MEETING NOTICE AND AGENDA
TECHNICAL ADVISORY COMMITTEE
OF THE
SEASIDE BASIN WATER MASTER

DATE: Wednesday, May 14, 2014

MEETING DATE:	May 14, 2014
AGENDA ITEM:	3
AGENDA TITLE:	Continued Discussion of New Survey Information on the Wang Subdivision Wells
PREPARED BY:	Robert Jaques, Technical Program Manager

**Revised and Updated Project-Specific Hydrogeologic Report
Peter and Grace Wang 26-Lot Subdivision
(PLN #010422)**

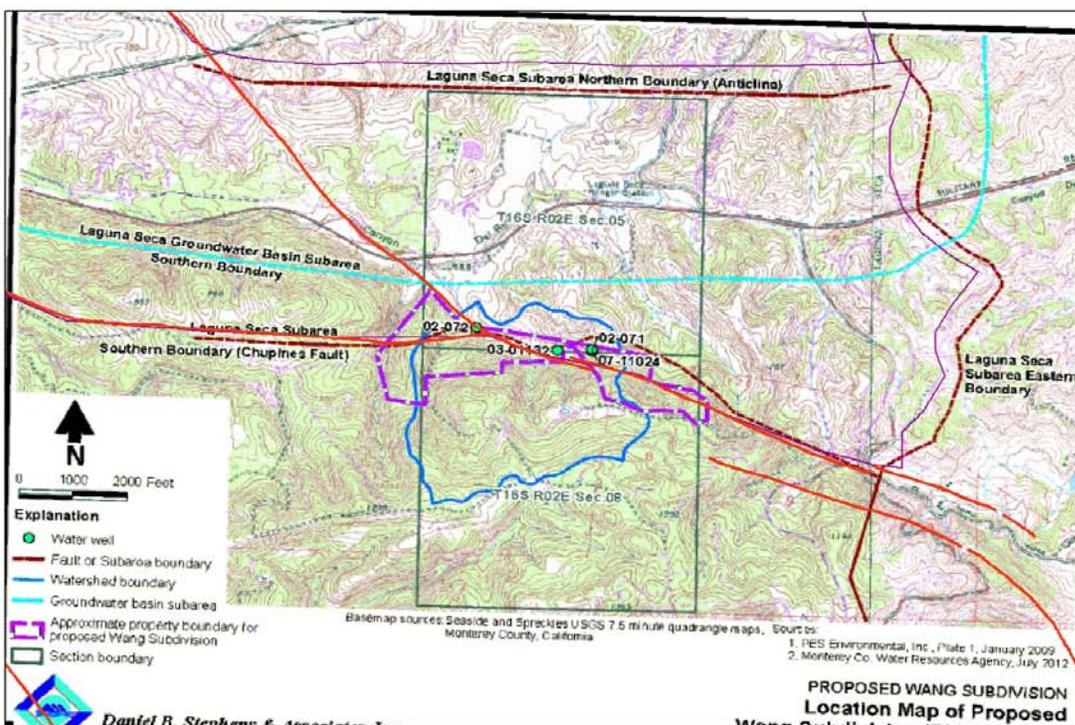
Figure 1, Location Map of Proposed Wang Subdivision. This map shows the location of the Wang property and wells, along with projections of the groundwater basin, subarea and Chupines Fault boundaries. We note that when this map is geo-rectified and compared with the GIS overlay coverage of the fault system and subarea boundaries from the Laguna Seca Phase III report (Yates and others, 2002), the boundaries do not precisely coincide. This is shown on **Attachment 1** below.

In particular, the location of the Chupines Fault is shown to wrap to the north of the main Wang wells on Figure 1 of the DBSA report, whereas the GIS overlay coverage shows fault traces plotting on the on the south side of these wells. The fault system coverage depicted in the Laguna Seca Phase III report was sourced from the from the USGS’s digital mapping of the Monterey and Seaside 7.5-minute quadrangles and Spreckels 7.5-minute quadrangle (Clark, Dupré and Rosenberg, 1997; and Clark, Brabb and Rosenberg, 2000; respectively). This uncertainty with respect to the Chupines Fault location on Figure 1 relative to the USGS map data, along with the paucity of water-level data, occurrence of Santa Margarita aquifer sediments adjacent to the Wang supply well screened intervals and lack of convincing evidence of an effective groundwater flow barrier between the Wang wells and the Laguna Seca Subarea as described above, underscores the need for a more comprehensive and defensible approach to resolving the issue of the hydrogeologic relationship between the Wang project wells and the Laguna Seca Subarea.
